DRAINAGE INFORMATION SHEET

GRADING AND DRAINAGE PLAN
CHRISTINA KENT DAY NURSERY

RE: REVISED DRAINAGE PLAN FOR AN ADDITION TO CHRISTINA KENT
DAY NURSERY (K-14/D43) REVISION DATED DECEMBER 19, 1988

RE: DRAINAGE & GRADING PLAN FOR AN ADDITION TO CHRISTINA KENT
DAY NURSERY (K-14/D43) RECEIVED NOVEMBER 9, 1988
ENGINEER'S STAMP DATED NOVEMBER 9, 1988

GRADING & DRAINAGE PLAN
BUILDING ADDITION TO THE
CHRISTINA KENT DAY NURSERY
423 THIRD STREET SW

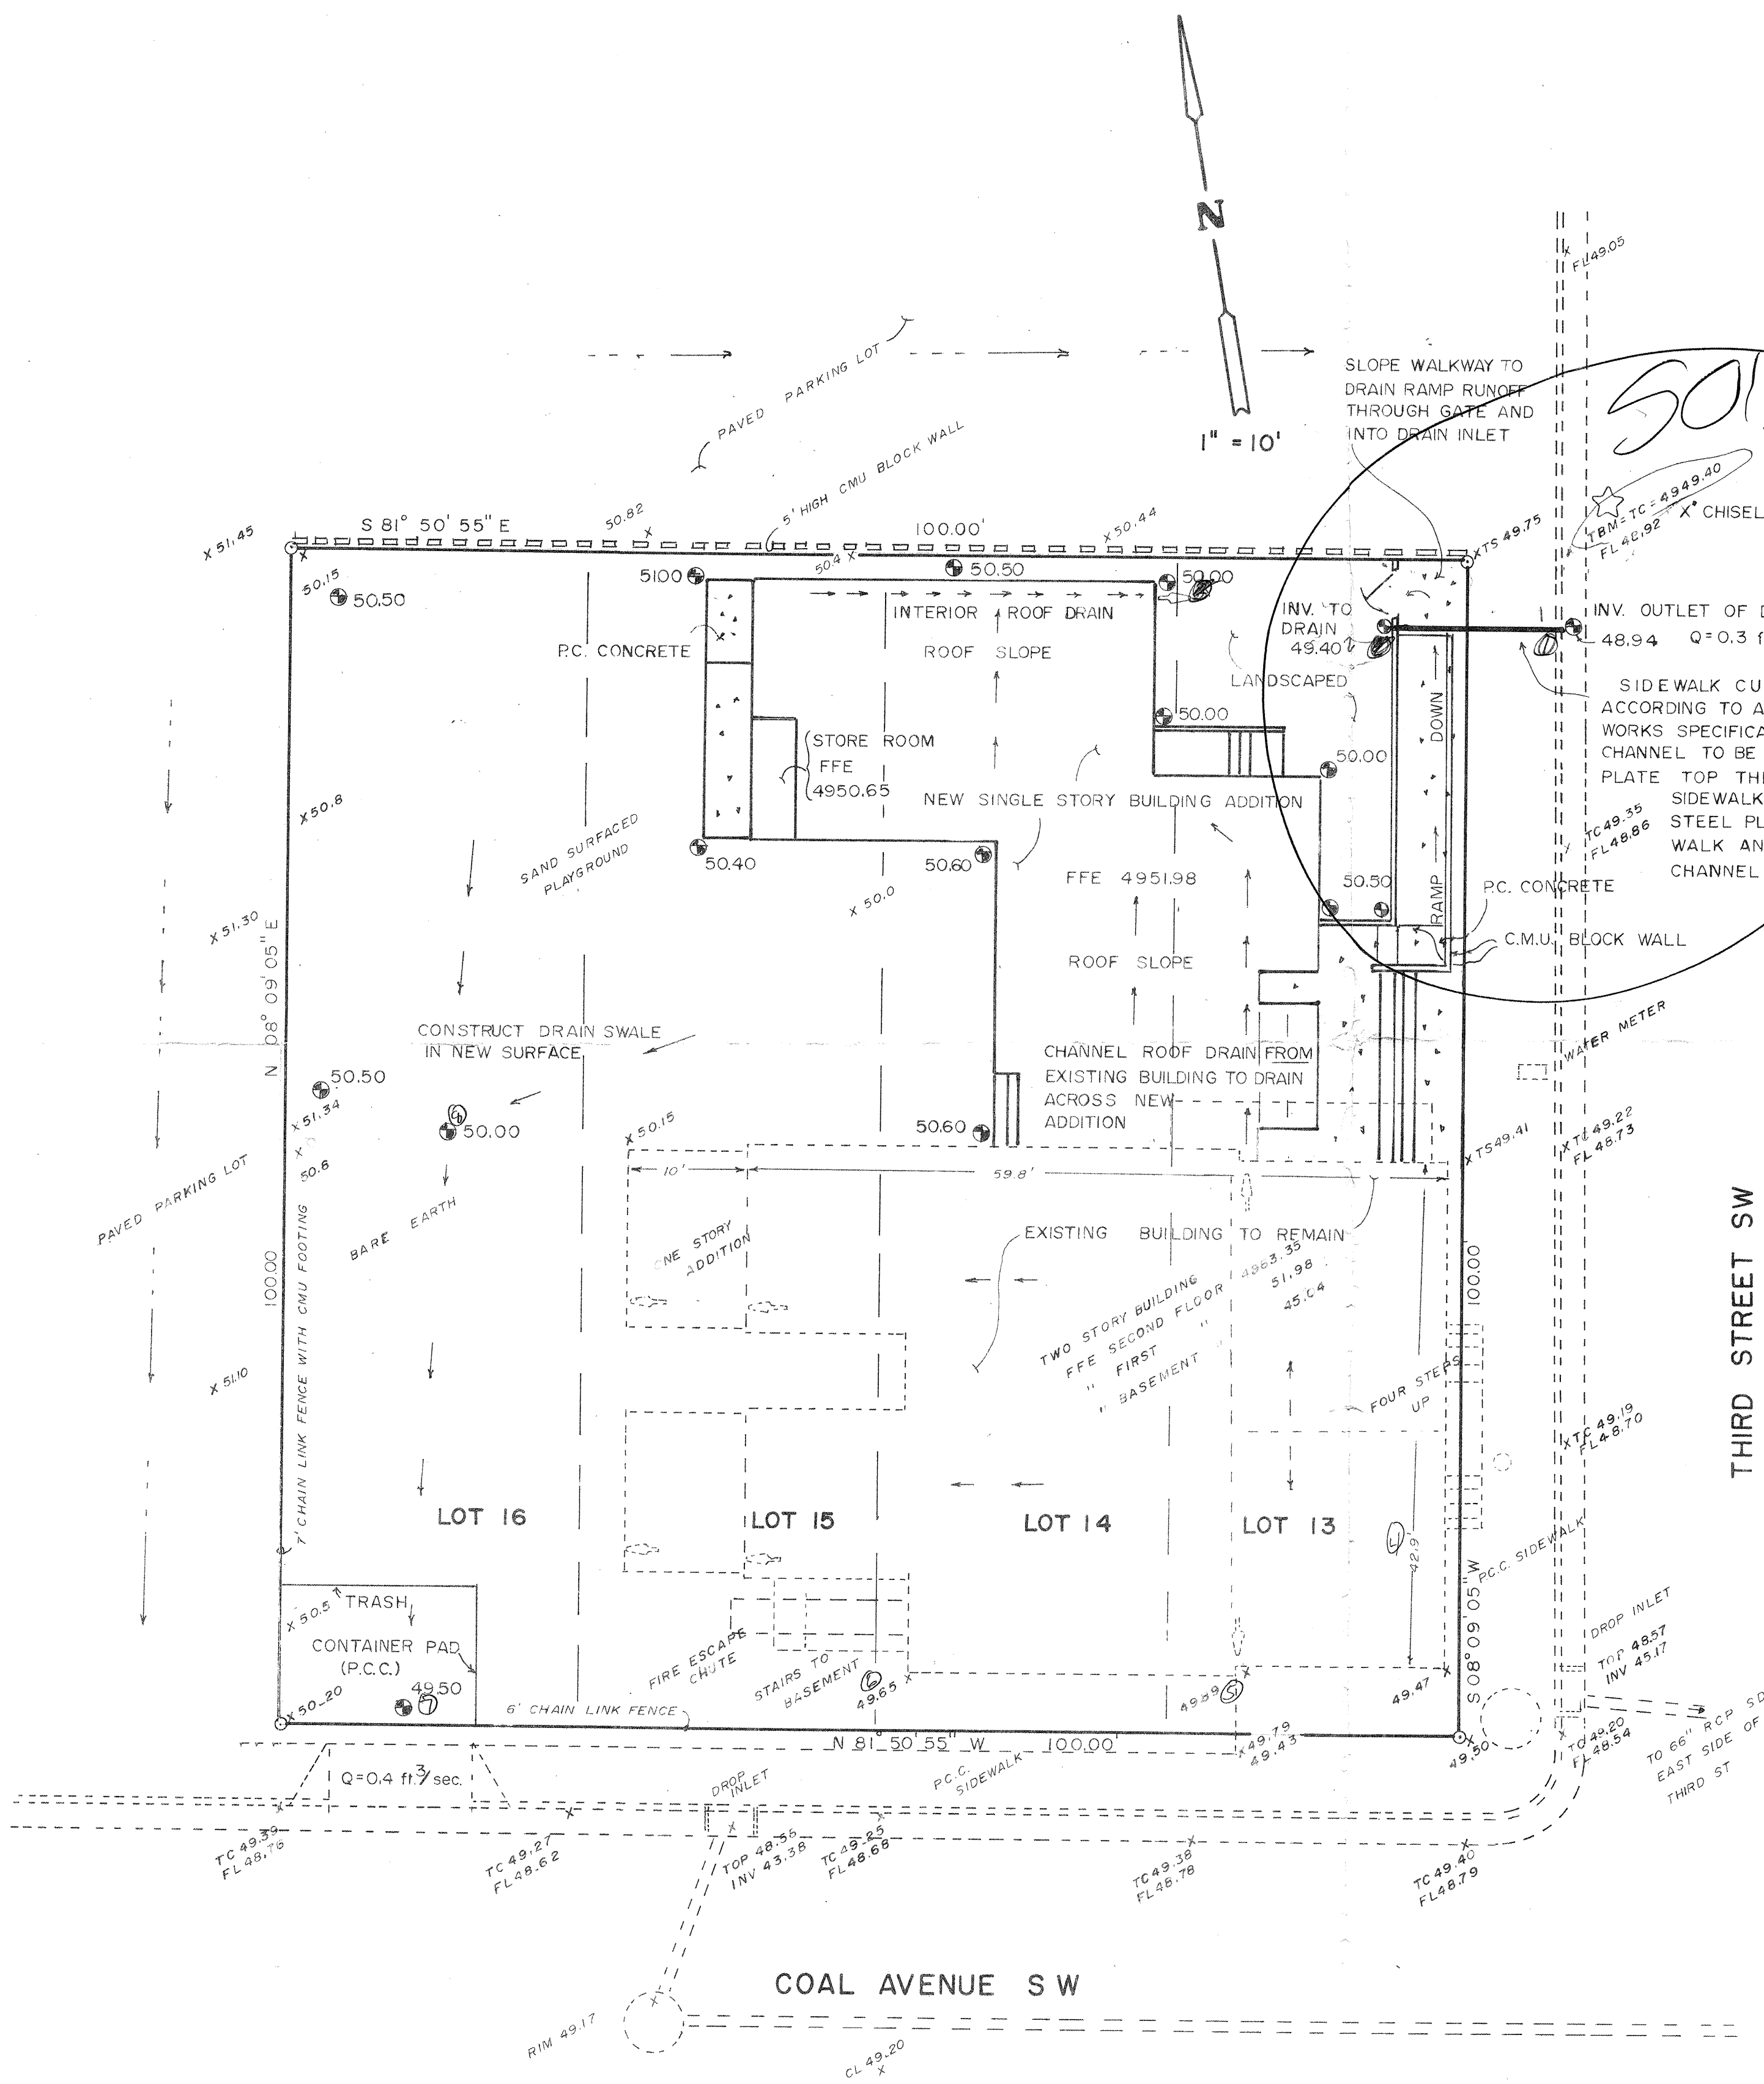
Attached to this letter is a drawing dated December 19, 1988 which has minor changes to the to the drawings which are in addition to the drawing changes made by reference B. The comments below state the nature of the changes:

- A. The roof slope is now to the north, with an interior drain to discharge toward the sidewalk culvert.
- B. The access ramp along the west has been moved to provide for clearance as required by the traffic engineer.
- c. A ground level storage room has been designed into the new addition, necessitating a grade change exterior to the building.

1. You must use the "Notice of Emergency Rule" to compute the developed and undeveloped flow rates and the SCS method to compute your volumes (see enclosed Notice of Emergency Rule).
2. How much runoff will be routed to the proposed 4" PVC penetration and is the pipe capacity adequate (please compute the pipe capacity and compare to the basin draining to it)?
3. It would be advisable to check with the Zoning Enforcement Section to see if they will require any paved parking areas. If so, please include with your calculations.
4. We will need two copies of your resubmittal.
5. What type of landscaping is proposed within the area that will have the 4" PVC pipe? Adequate steps must be taken to assure that the pipe is not plugged.
6. T.B.M. must be permanently marked.

The above changes do not change the proposed drainage plan. I request your review and approval of the plan.

1. The Notice of Emergency Rule has been used to recalculate the flow rates. The drainage plan includes revised pages and paragraphs to reflect the changes.
2. There will be a peak flow of 0.3 ft.³/sec. routed to the under sidewalk culvert near the northeast corner of the site. Please note that this is a change from the originally proposed 4" pipe.
3. Parking for the site is provided by already existing paved parking on adjacent property. Please see attached letter of agreement.
4. Two copies of this resubmittal are being provided.
5. Attached is a copy of the proposed landscaping. There should be little risk of the under sidewalk culvert plugging as it will have a larger cross section than the 4" pipe.
6. The temporary bench mark (T.B.M.) is now permanently marked with a chiseled "X".
